SUBJECT: Forwards responses to open items discussed at 811117-18  
 Geosciences meeting. Remaining responses will be transmitted  
 prior to 811231.

December 22, 1981  
G02-81-541  
SS-1-02-CDT-81-111

Subject: NUCLEAR PROJECT NO. 2  
GEOSCIENCES BRANCH OPEN ITEMS

<p>WASHINGTON PUBLIC POWER SUPPLY SYSTEM Nuclear Project No. 2</p>	<p>PHOTOGEOLOGICAL INTERPRETATION OF LINEAMENTS AND POSSIBLE CAPABLE FAULTS BETWEEN WARM SPRINGS CANYON AND MILTON-FREEWATER</p>	<p>Figure 360.16-1</p>
--	--	----------------------------

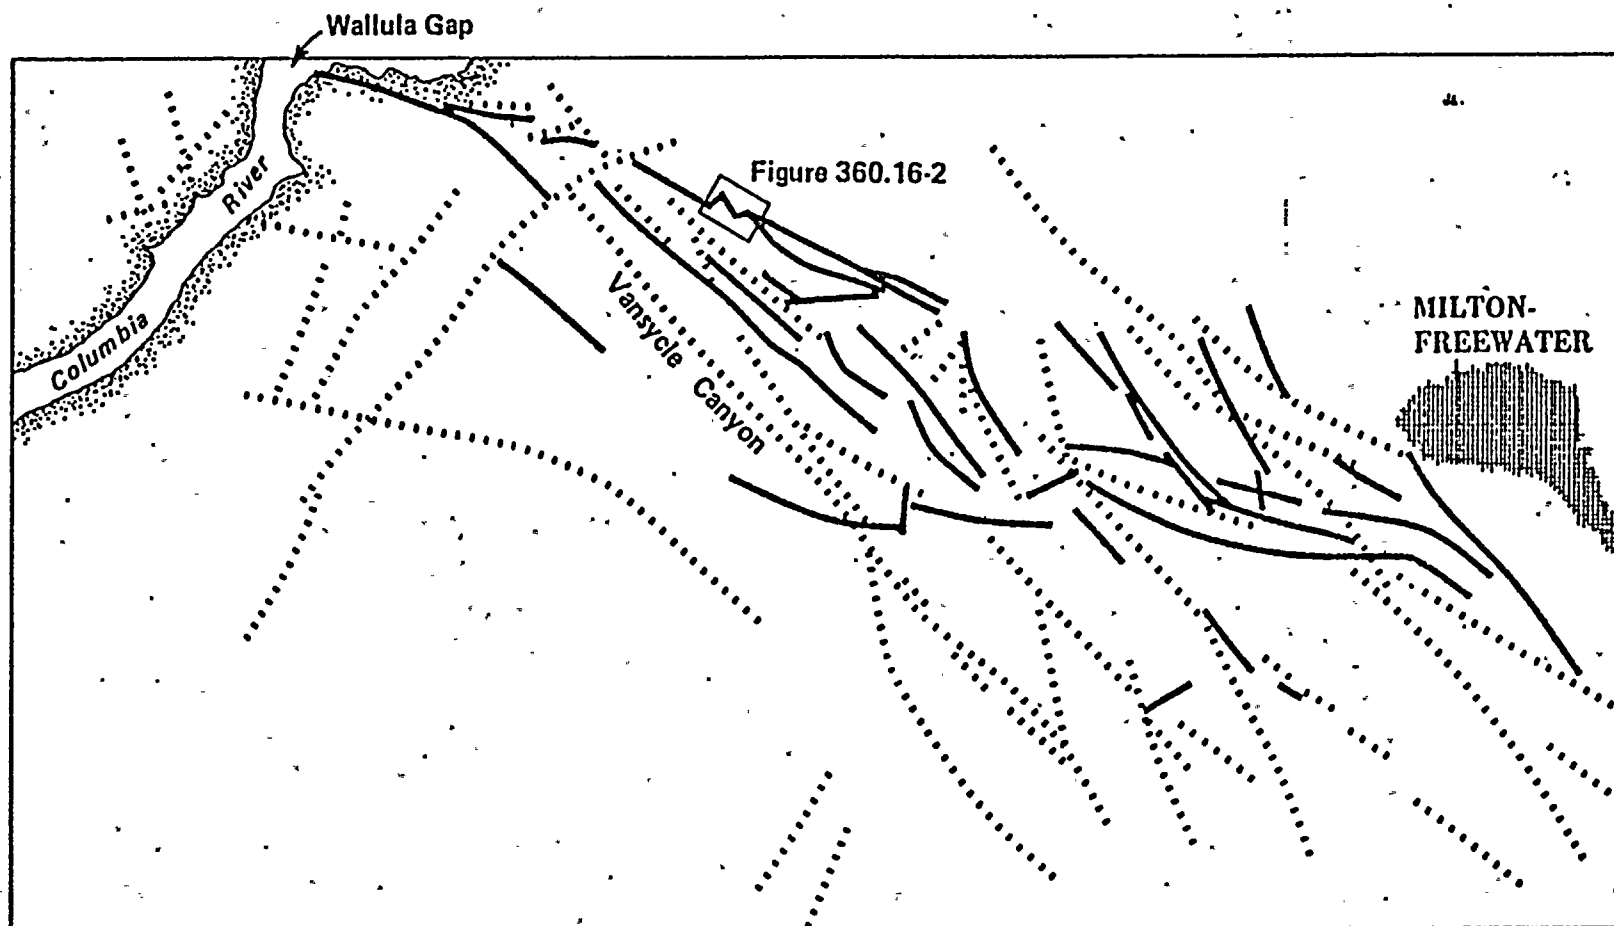
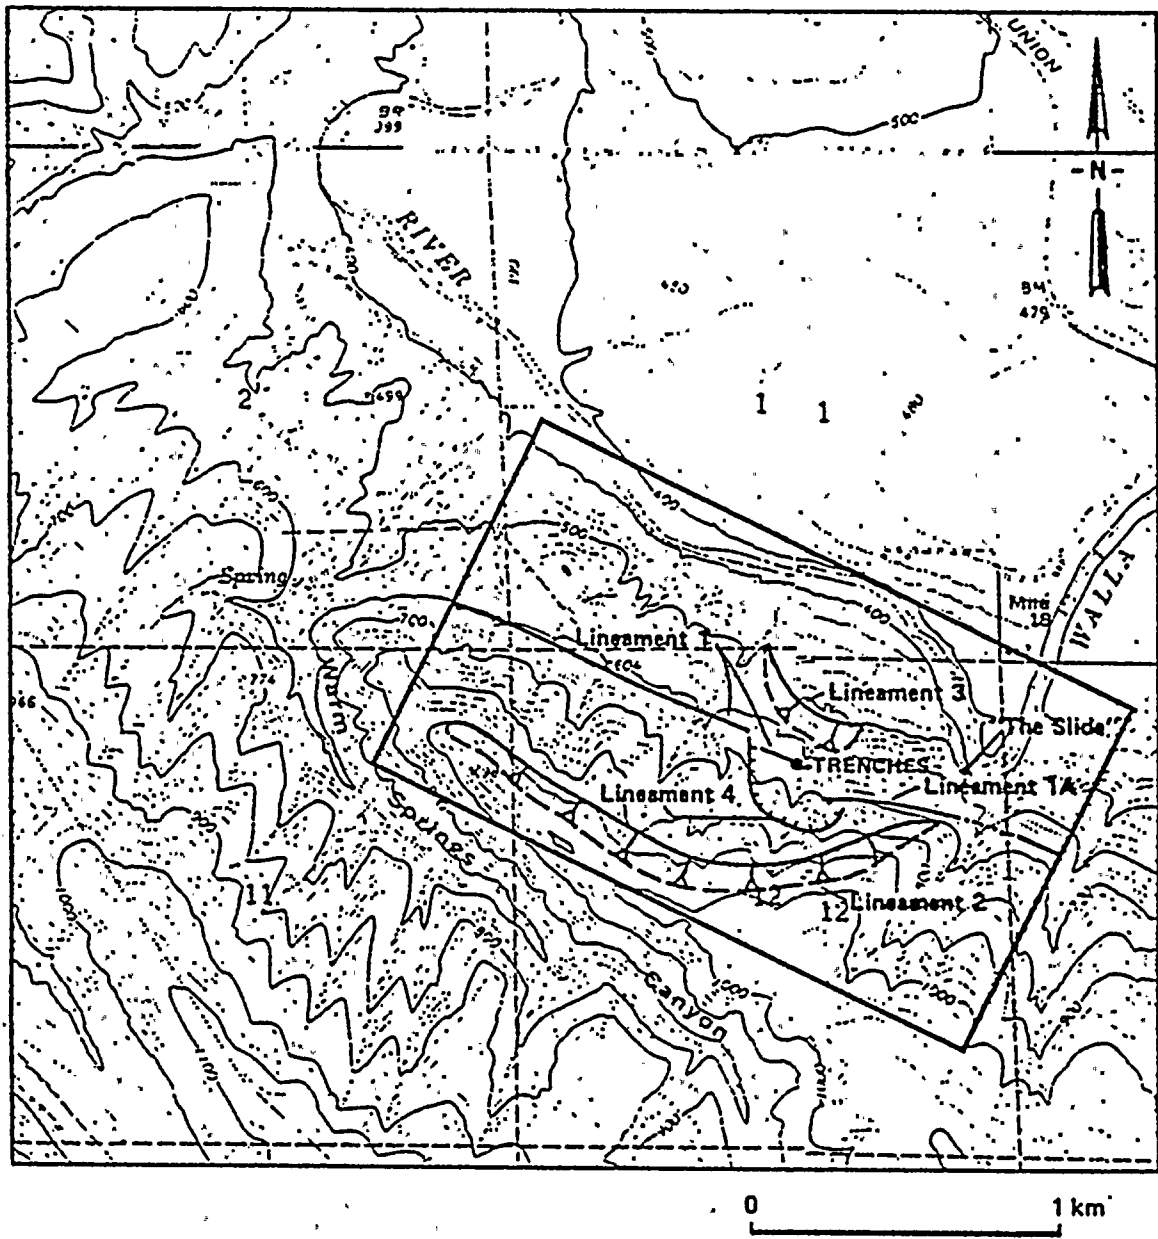
- a. Figures 20a and 20b are from Vansycle Canyon: Have the youthful-appearing faceted spurs having linear character been investigated for possible young age and, therefore, capability? What is the explanation for this feature?
- b. Figures 21a and 21b taken South of Umapine: Has the pronounced escarpment on the lower third of the hill in the center/upper right of 21a and in the center/right of 21b been investigated for possible recent movement? What is the explanation for this feature?

The origin of the faceted spurs east of Wallula Gap was investigated as part of the trenching and mapping investigation of the Wallula Gap fault (Woodward-Clyde Consultants, 1981). A regional reconnaissance was made of the lineaments and faceted spurs between Wallula Gap and Warm Springs Canyon, including the Vansycle Canyon lineament and three trenches were excavated across the Wallula fault southeast of Warm Springs Canyon (Figure 360.016-1). Based on these studies, the faceted spurs are interpreted to be the result of differential erosion across geologic contacts (both depositional and fault contacts) between different basalt flow units. The scarps south of Umapine were not specifically investigated as part of this study.

Lineament no. 1 near Warm Springs Canyon (Figure 360.016-2) is defined by an alignment of north facing faceted spurs and a broad bench that lies immediately north of the break in slope at the base of the spurs. Lineament no. 1 is coincident with the Wallula Gap fault. The bases of the higher and more-pronounced faceted spurs along lineament no. 2 are approximately coincident with the contact between the upper and lower units of the Frenchman Springs Member.

Figure  
360.20-1

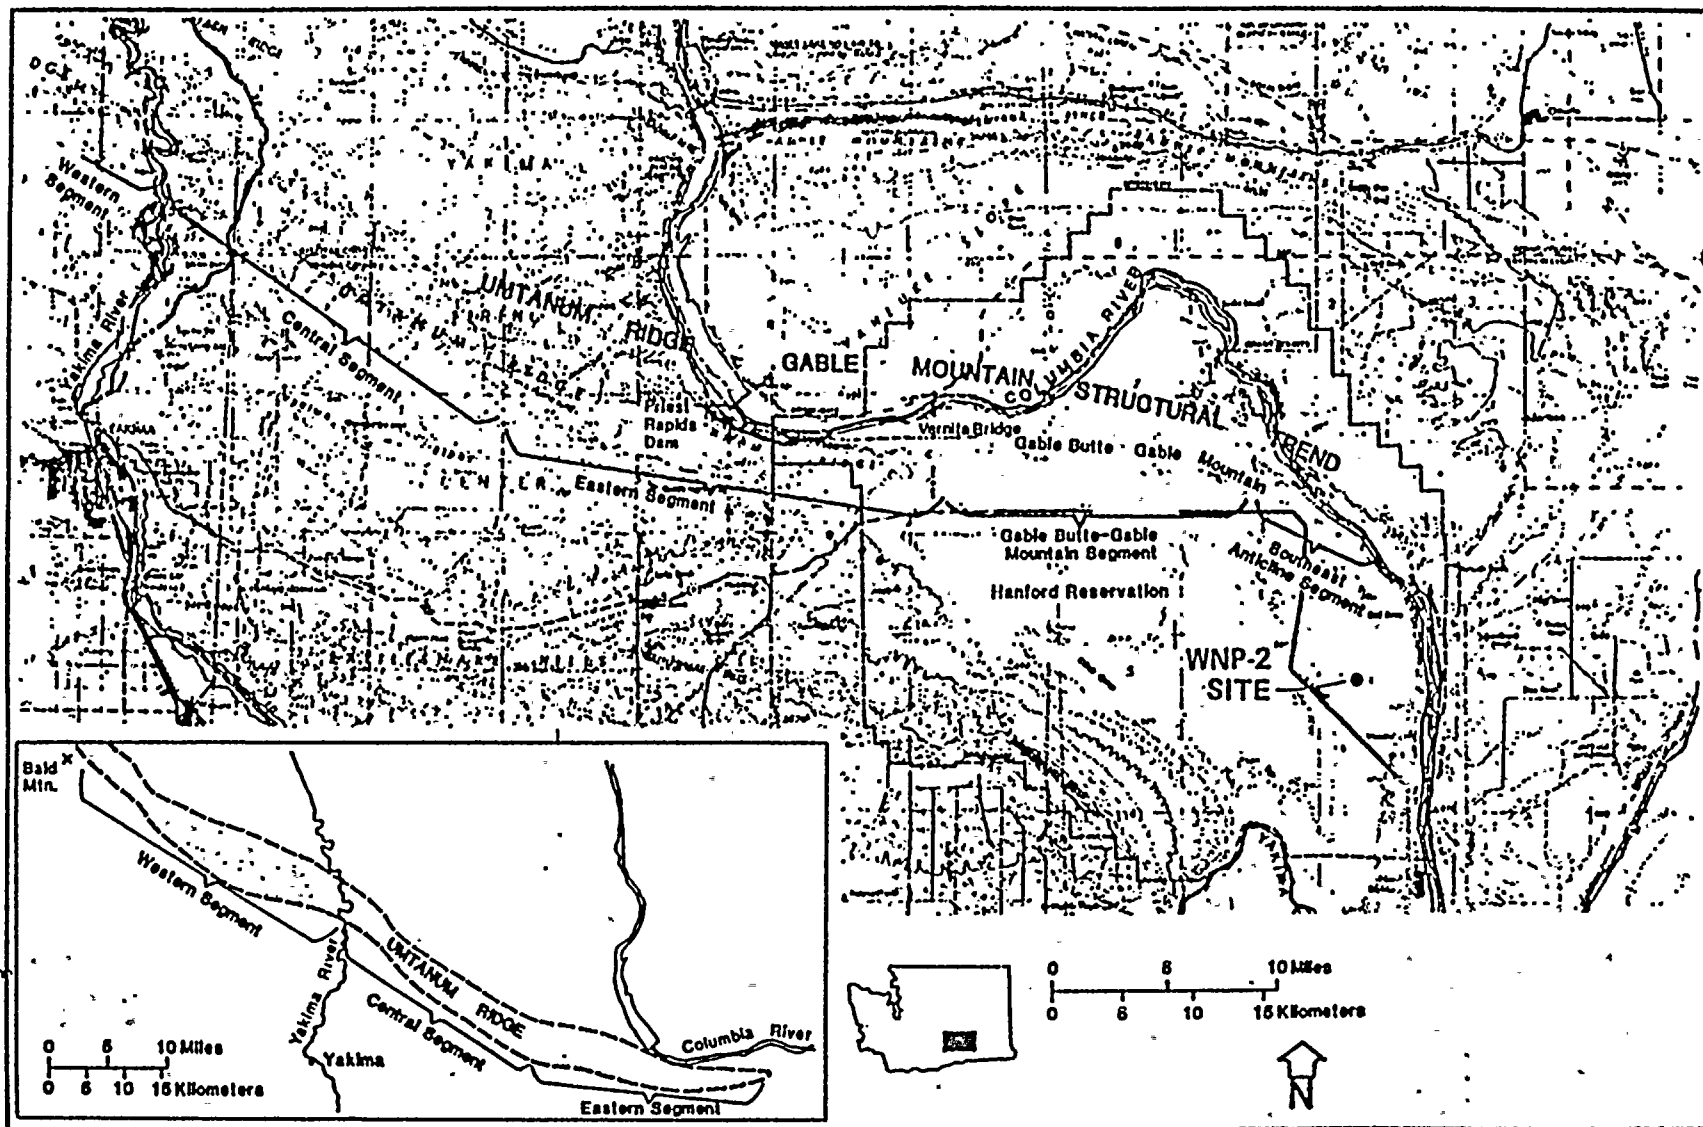
Provide a summary of all prominent structures (other than those incorporated into Question 360.014 as part of the (CLEW) in the site region, discussing in detail their character and capability with supporting evidence for your judgement. If you determine any to be segmented, provide a map on topographic base delineating the segments and discuss in detail the character and capability of the individual segments with supporting basis.

- o The Umtanum Ridge-Gable Mountain structural trend is a segmented anticlinal high.
- o The structural trend is comprised of five segments (Figure 360.020-1) that are separated from each other on the basis of changes in the style of deformation and fold orientation. Individual segments show marked differences in fold vergence, fold amplitudes and widths, and development of first, second, and third-order folds.
- o The Umtanum fault and other east-west trending reverse faults are inferred to be products of fold deformation in a north-south compressional stress regime. Geologic

<p>WASHINGTON PUBLIC POWER SUPPLY SYSTEM Nuclear Project No. 2</p>	<p>SCHEMATIC OF TREATMENT OF INHERENT UNCERTAINTY IN EXPOSURE MODEL</p>	<p>Figure 361.18-1</p>
--	---	----------------------------

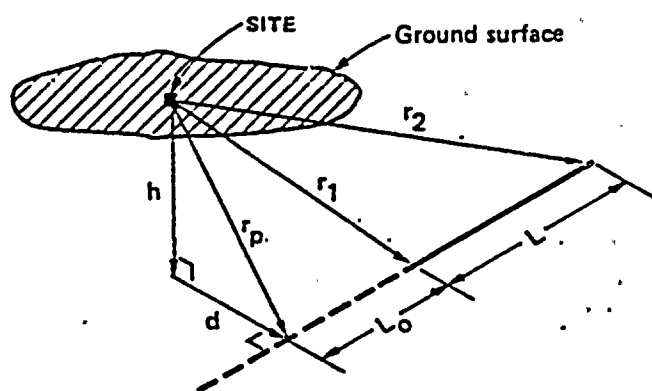
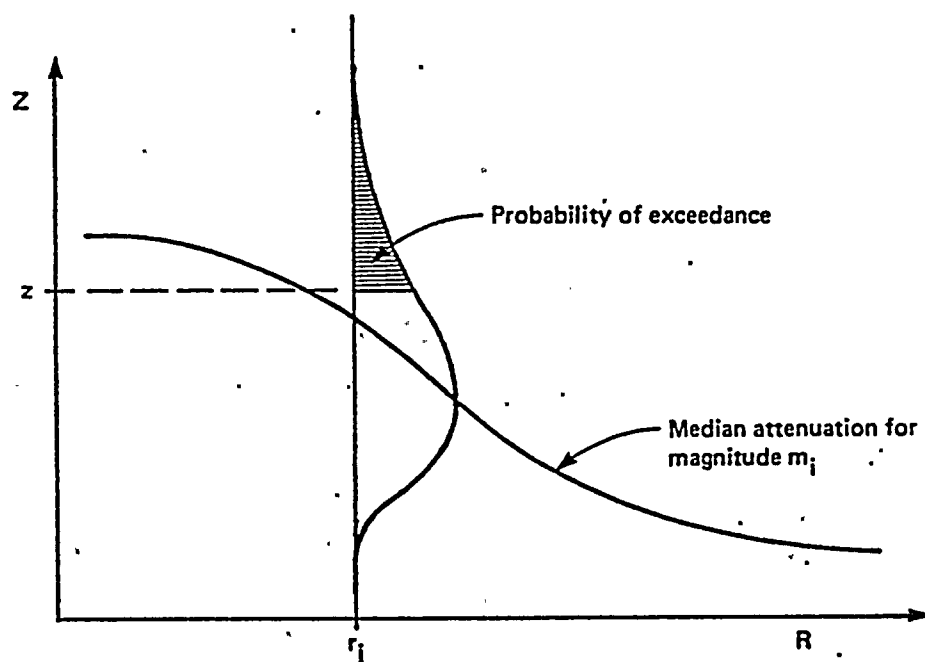
Provide a discussion on how, and at what stage, uncertainty was accounted for in the seismic exposure analysis (including graphical examples).

The uncertainty in the location of the earthquake on the source is characterized by assuming a uniform distribution for the location of the rupture surface. This is shown schematically in Figure 361.18-1a.

The probability of exceedence given a particular magnitude and distance is calculated from the distribution about the median estimate of attenuation of ground motion, as shown in Figure 361.18-1b. By summing over all possible magnitudes and distances, a mean rate of exceedence is calculated which expresses the inherent uncertainties in a Poisson process.
